Amendment No. 008

Technical Questions and Answers

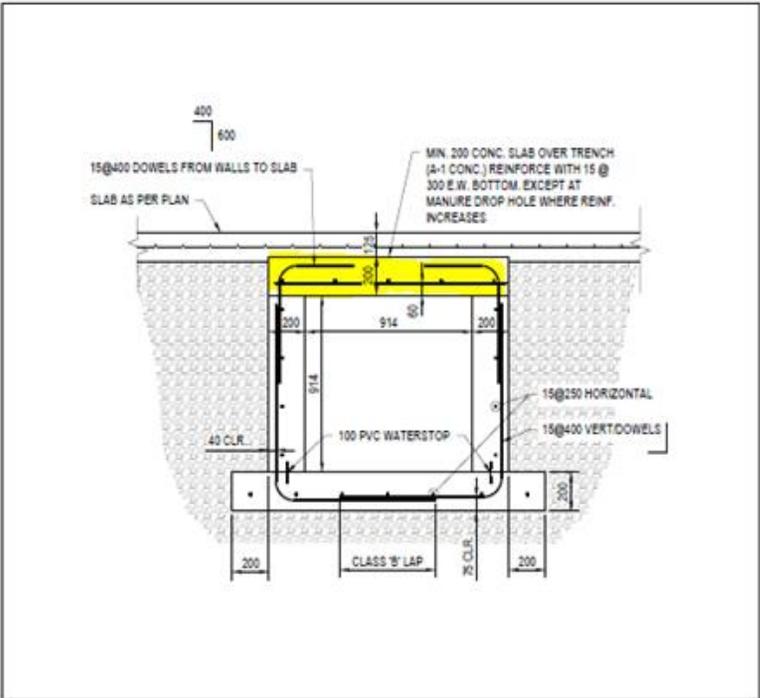
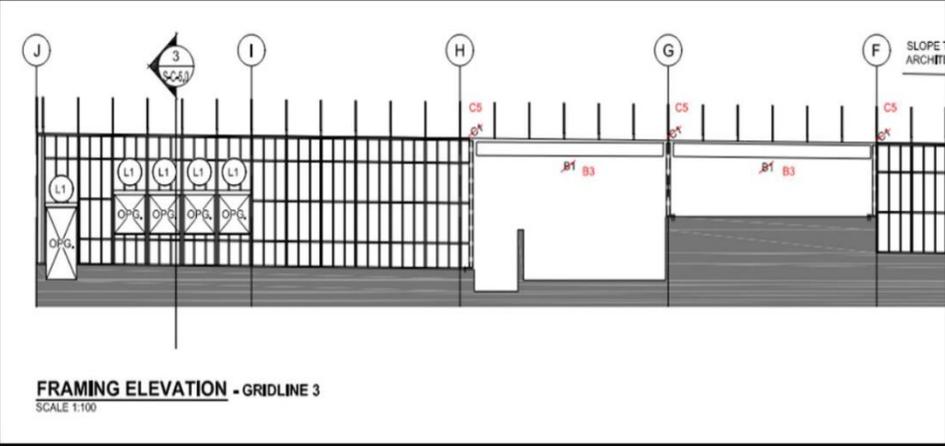
<p>8 An alternative to a total pre-cast tunnel, could the top slab (see yellow highlighted section in screenshot below) be made of precast? The reason for this inquiry is the length and inside diameter of the tunnel making a very small confined space to strip after pouring. It would result in us having to make very small pours for the top slab in order to make stripping the top slab safe for our workers. Not only is it a confined space risk, it would be to do so many small pours. Precast is a much more efficient product in terms of installation and cost.</p>	<p>The tunnel is to be cast in place as detailed.</p>
<p>(35 cont)</p>  <p>The diagram is a cross-section of a tunnel. The top slab is highlighted in yellow. It shows a concrete slab with reinforcement. Labels include: '15@400 DOWELS FROM WALLS TO SLAB', 'SLAB AS PER PLAN', 'MIN. 200 CONC. SLAB OVER TRENCH (A-1 CONC.) REINFORCE WITH 15 @ 300 E.W. BOTTOM. EXCEPT AT MANURE DROP HOLE WHERE REINF. INCREASES', '15@250 HORIZONTAL', '15@400 VERT. DOWELS', '100 PVC WATERSTOP', '40 CLR.', 'CLASS 3 LAP', 'K CLR.', '200', '914', '814', '200', '200', '200'. A circular callout at the bottom left contains the number '9' and the text 'SECTION' and 'SCALE: 1:20'.</p>
